# ALTERATION TO A HISTORIC PROPERTY STAFF REPORT

Site: 39-49 Bow Street c.1900 Apartment Rowhouses
Case: HPC 2016.049 Bow Street Local Historic District

Legal Notice: Replace stair and decking material, Alter railings on rear porches.

Staff Recommendation: Conditional Certificate of Appropriateness

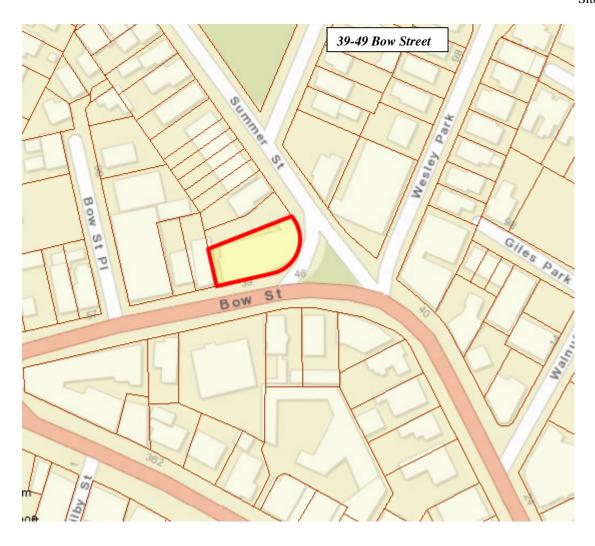
The Sanborn Maps give the configuration of the original porches and their material – wood. Over the years, the Commission has developed a generic porch rail, baluster and post system that works well with various building styles. The Applicants are proposing a variant on this system.

3<sup>rd</sup> floor deck

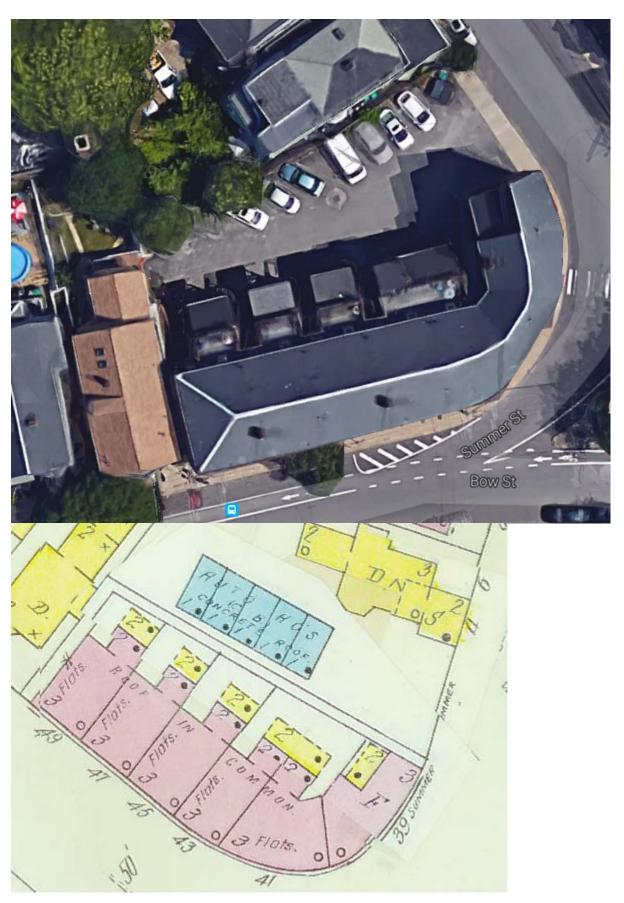
The existing porches are of an inappropriate style for the building and do not meet building code. See photos.

While the proposal is to use non-historic materials for a portion of the porches, stylistically the proposed posts, railings and balusters would be of a generic style indicative of the lack of information as to the original forms and styles used on the original rear porches and would not detract from the character of the building. The posts will be wrapped giving them a slightly beefier appearance to the existing posts. The stairs will be reconfigured slightly to meet code. Posts will be wrapped to give them more visual weight.

- 1. If the changes are necessary to the prosed design for which this Certificate of Appropriateness was issued, new plans shall be submitted to Historic Staff prior to commencing the work.
- 2. All rear decks shall be replaced on the first and second floors.
- 3. All railings shall be composed of a bottom and top rail with2" square wood balusters, hand and foot rails.
- 4. The stairs shall be rebuilt with wood steps and risers.
- 5. The deck material shall be wood except the third floor which may use Veranda Nantucket Gray composite decking
- 6. The posts shall be wrapped to the dimensions of 5" x 8" over the existing posts.
- 7. Railings, balusters and posts shall be painted.
- 8. Historic Staff shall issue a sign-off upon completion of the project that this was done in accordance with the Certificate and approved plans.
